ADDRESS: 700-02 AND 704 CHESTNUT ST

Proposal: Demolish building, construct addition

Review Requested: In Concept

OVERVIEW: This application proposes the in-concept approval of the demolition of the building at 704 Chestnut Street and the construction of an addition to the building at 700-02 Chestnut Street. Currently, both buildings, at 700-02 and 704 Chestnut Street, are classified as contributing to the Chestnut Street East Historic District. In parallel with this application, the applicant is requesting that the Committee on Historic Designation and Historical Commission reclassify the property at 704 Chestnut Street as non-contributing to the historic district. If the Historical Commission declines to reclassify 704 Chestnut Street as non-contributing, then it cannot approve the demolition without a finding that the demolition is necessary in the public interest or that the building has no feasible reuse. The Architectural Committee should craft a recommendation for both scenarios, with the property at 704 Chestnut Street classified as contributing and non-contributing.

1 SHT-SITE PLAN
1/16" = 1'-0"

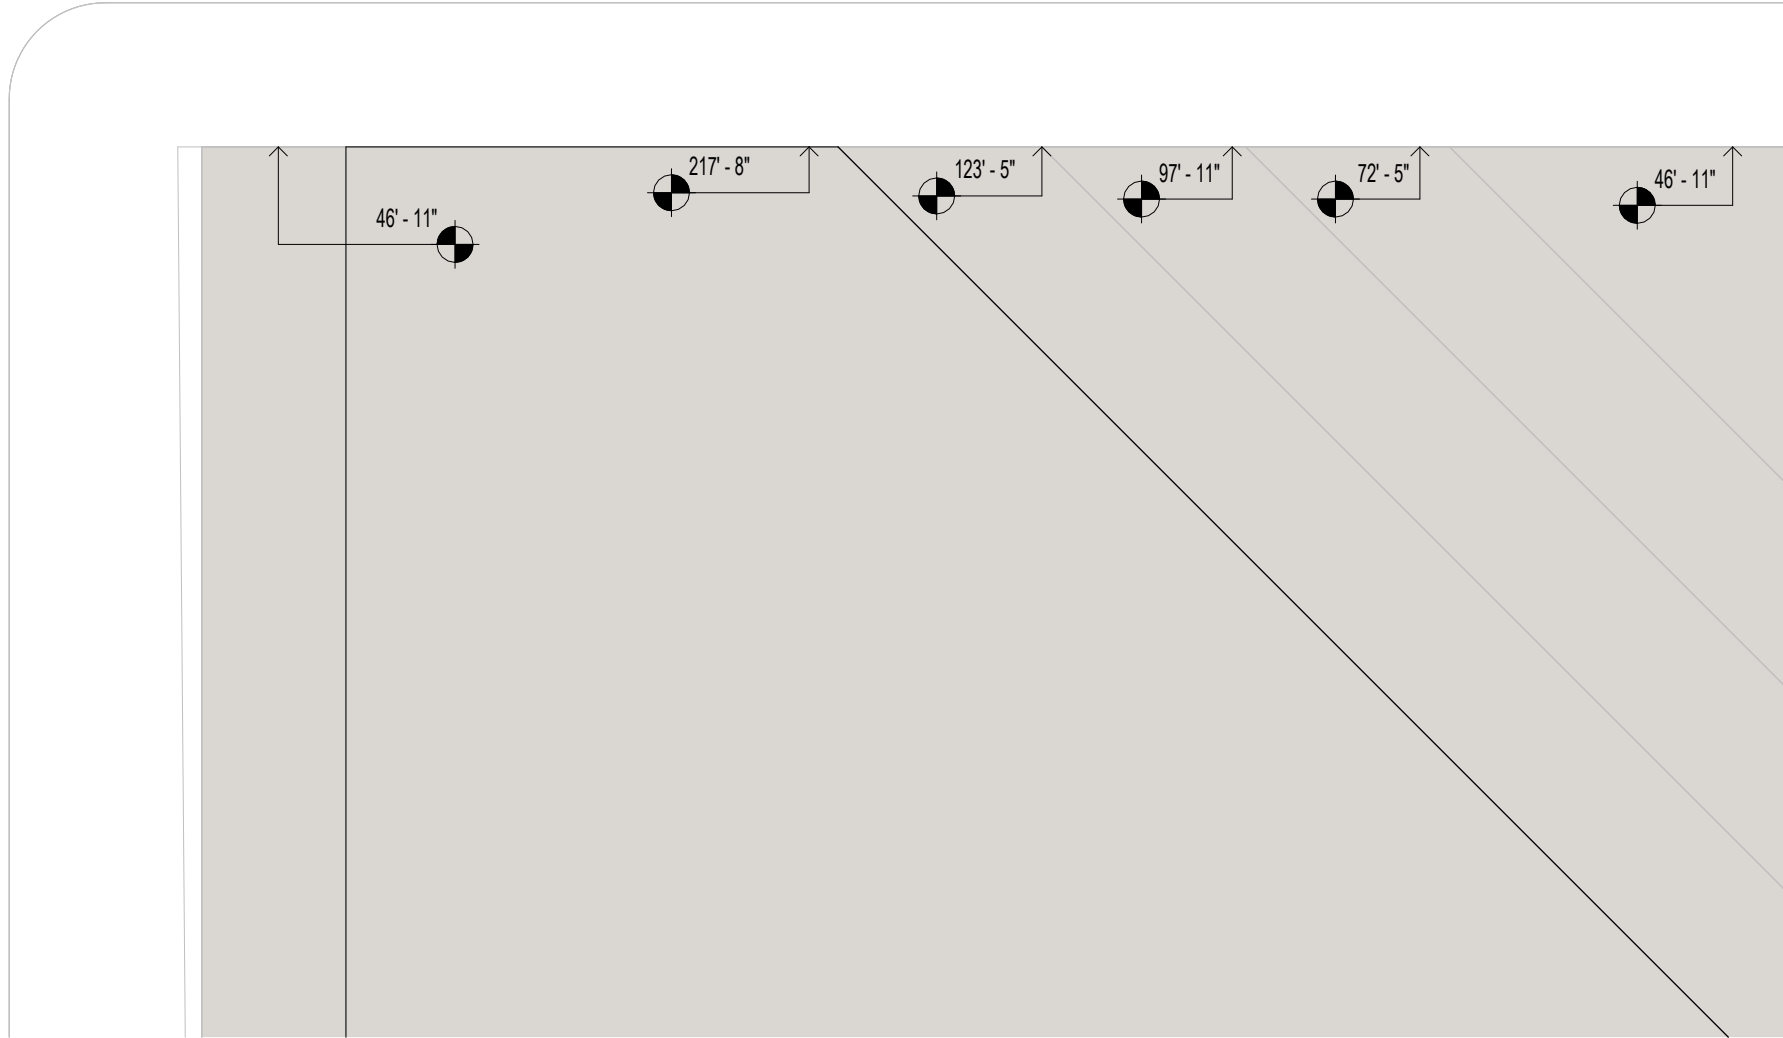
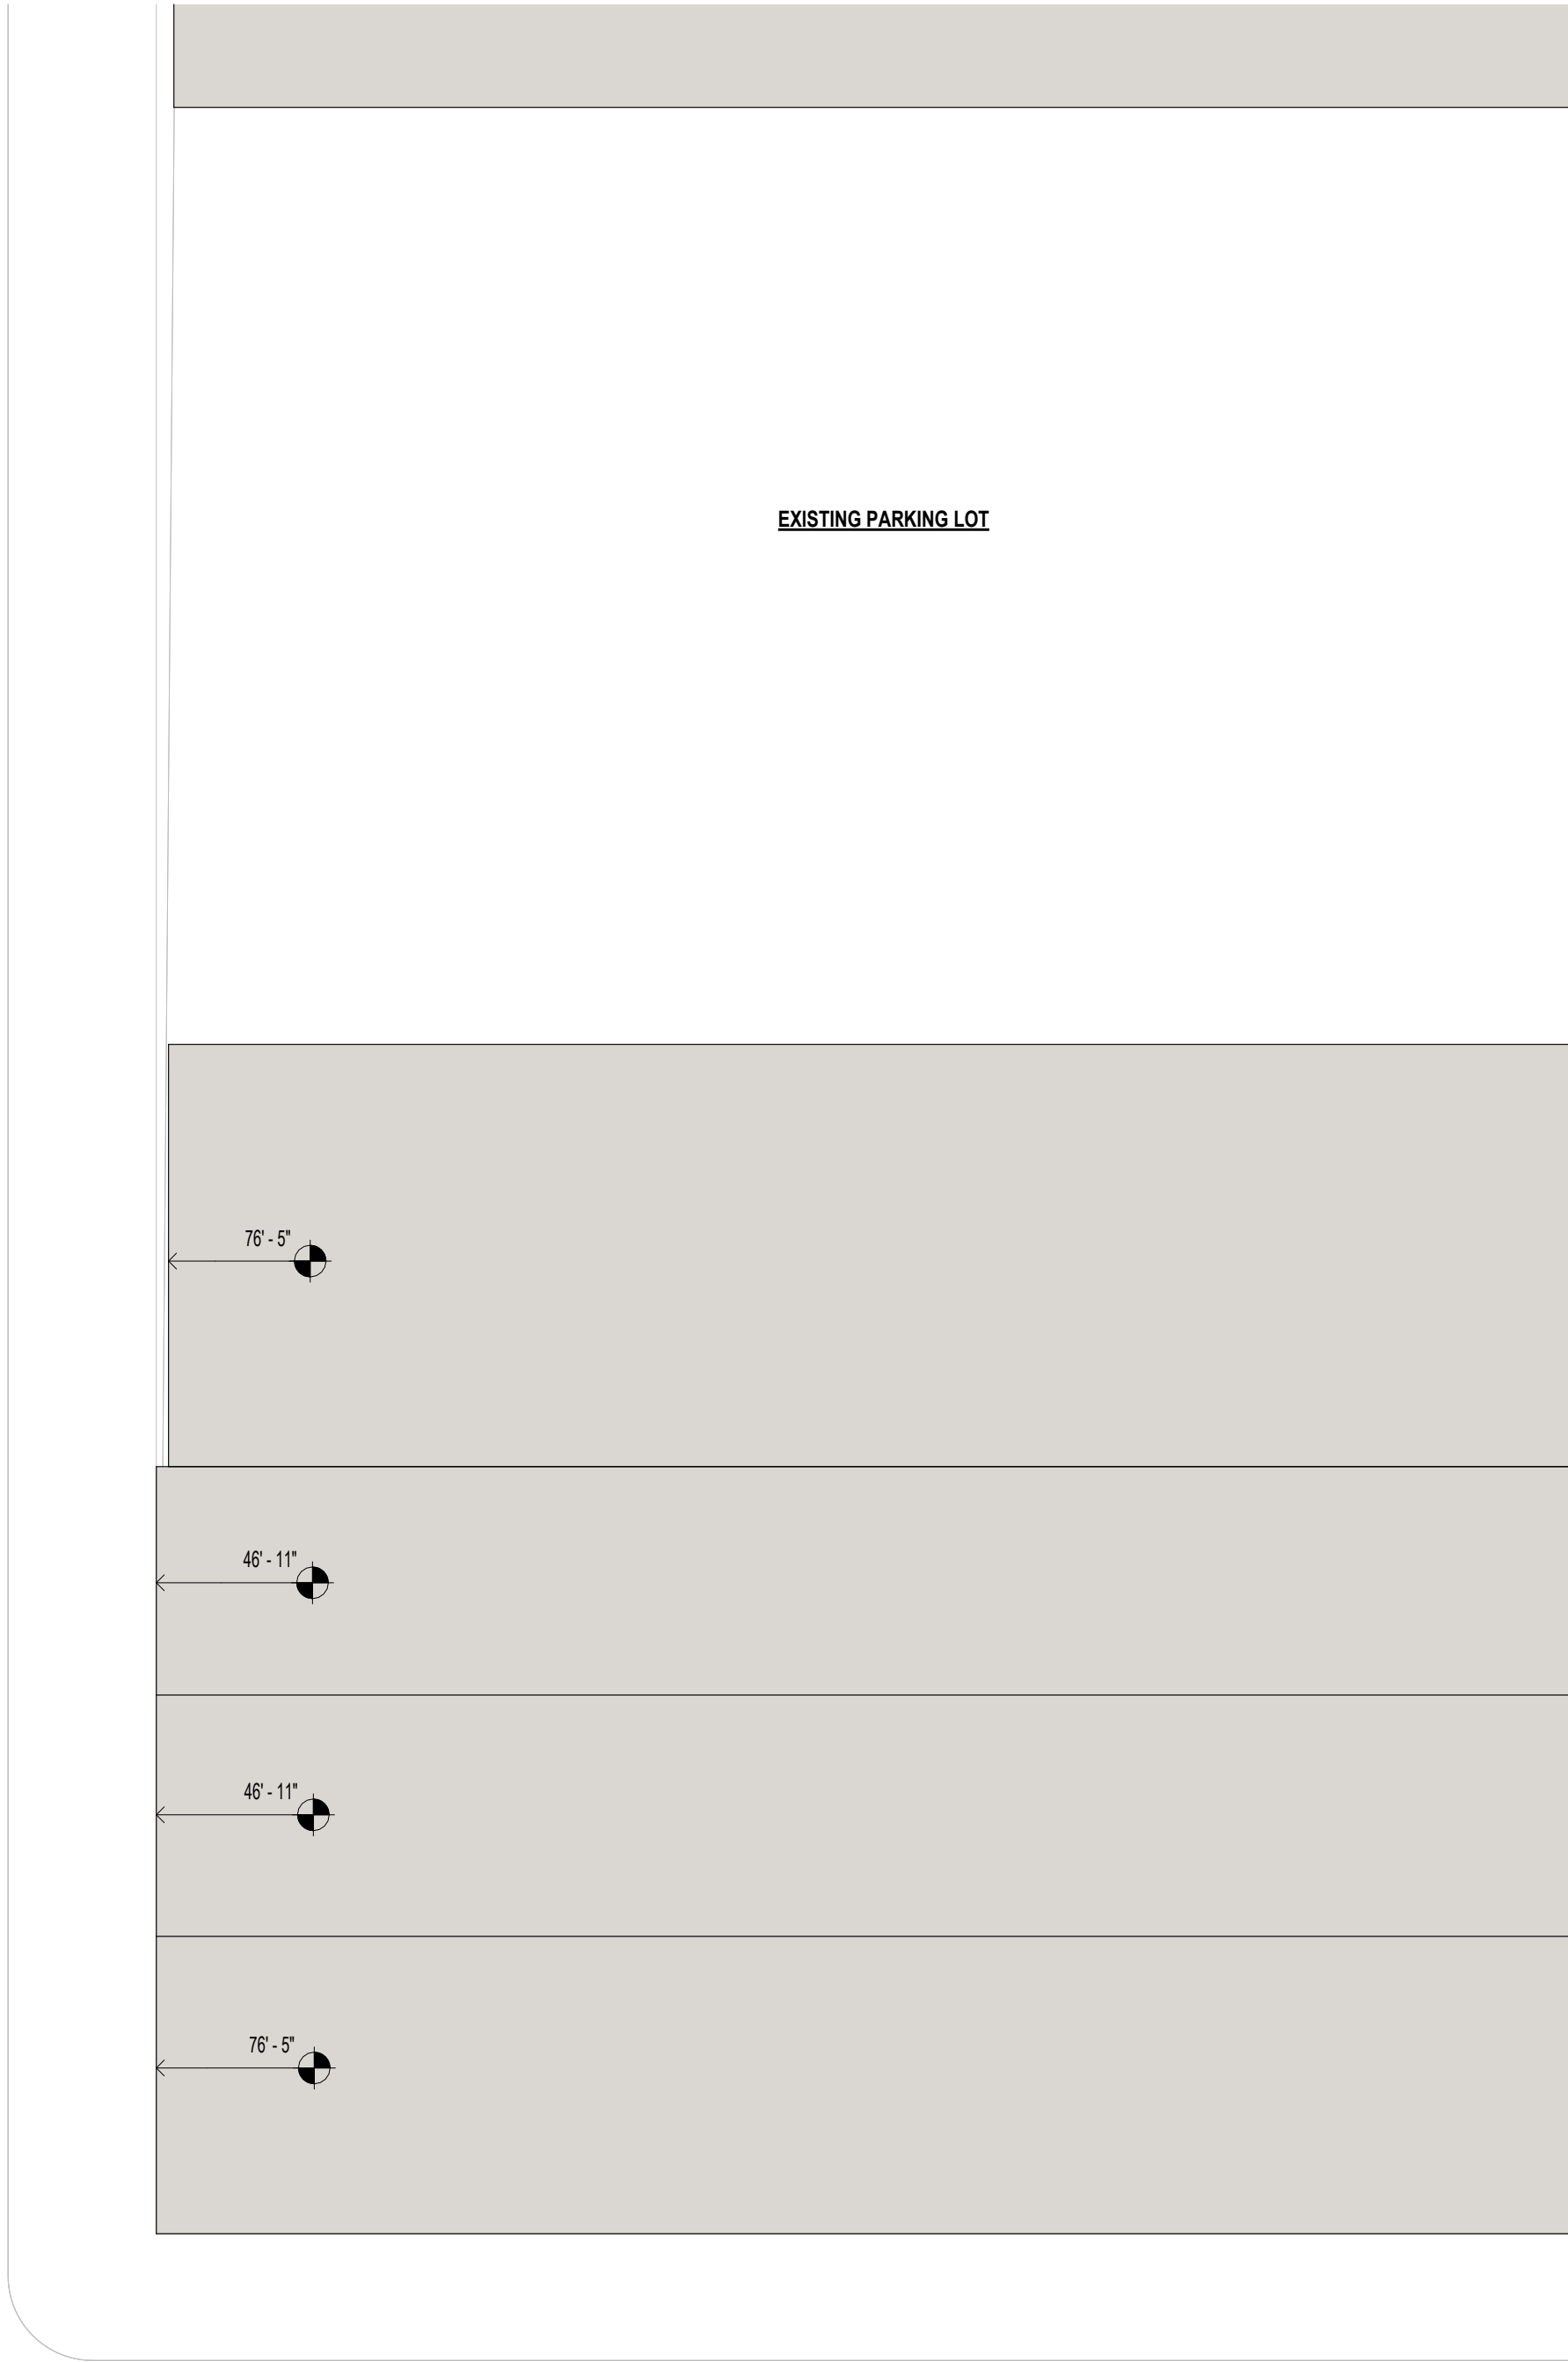
- If the addition is constructed, it will not be compatible with the historic materials, features, size, scale and proportion, and massing of the building at 700-02 Chestnut Street or the historic district as a whole and therefore will not protect the integrity of the property and its environment, and will not satisfy Standard 9.

STAFF RECOMMENDATION: The staff recommends denial of the in-concept application, pursuant to Standard 9 and, depending on the outcome of the reclassification review, Section 1401005(6)(d) of the Philadelphia Code, the prohibitions against demolition.
